Super BigBite Coordinate Detector (CDet) Review

25 February 2014

A technical review of the proposed Super Bigbite Spectrometer (SBS) Coordinate Detector (CDet) was held February 25, 2014. This is a PMT-based scintillator hodoscope designed to replace a GEM-based equivalent that was described in an early SBS program design.

Figure 1: Averaged energy deposition in one channel for a 3 mm rectangular scintillator (left panel), and 3 mm trapezoidal scintillator (right panel). Figures reproduced from p. 4 of [2].

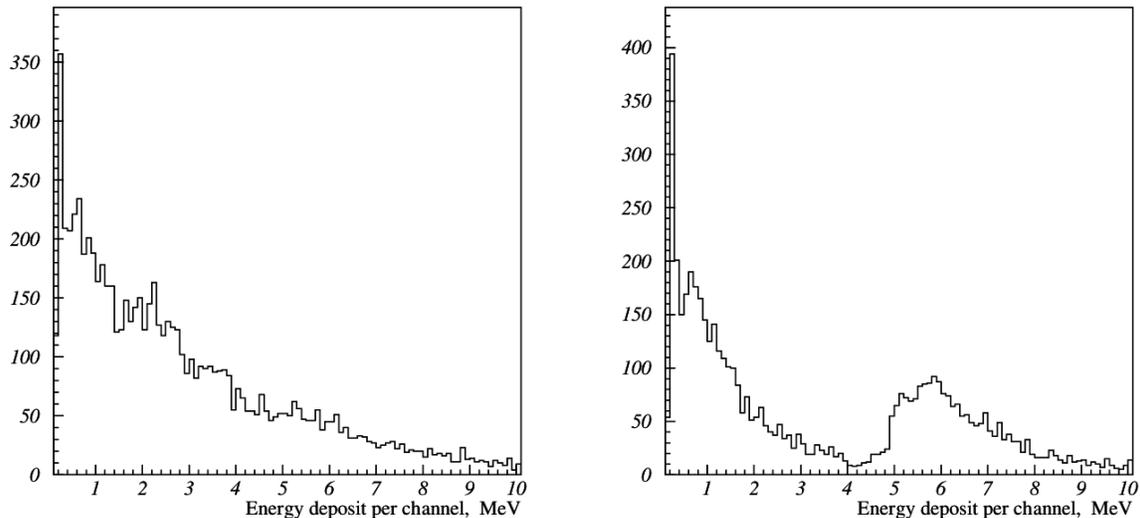
In the end, it is believed that achieving such precise angular alignment across the array is very unlikely without a large investment in time and expense. Unfortunately it is unclear what effect this will have on the CDet performance, some of the provided documentation suggests the impact may be significantly negative. For example, Figures 6 and 7 of the *Coordinate Detector Simulations* document [2] referenced in the Design Report show very different energy deposition profiles for a bar with a rectangular cross section *vs.* one with a trapezoidal cross section. Figure 1 shows a reproduction of those two energy distributions. The accompanying text in [2] comments on the significant advantages of the trapezoidal tilted-bar alignment over a rectilinear array including much better signal to background discrimination (for reasons evident in (Fig. 1)), significantly reduced hit multiplicity in the array, and (though unstated in the document) improved coordinate resolution due reduced energy sharing across adjacent bars.

The impacts of “real-world” fabrication, assembly, and alignment tolerances need to be investigated more thoroughly here to make sure that the CDet will provide the needed resolution and background tolerance even if the bars are significantly “misaligned” *vs.* the incident electron trajectory.

1. Evaluate the sensitivity of the CDet performance to variations in the scintillator bar alignment using MC simulations. Earlier MC results (Fig. 1) suggest the alignment impact may be quite large. It is very unlikely that $\approx 50 \mu\text{m}$ tolerances are achievable without a significant increase in cost. The dead area between the bars due to TiO₂ layers and non-uniformities in bar thickness should also be evaluated. (Sect. 4.1)
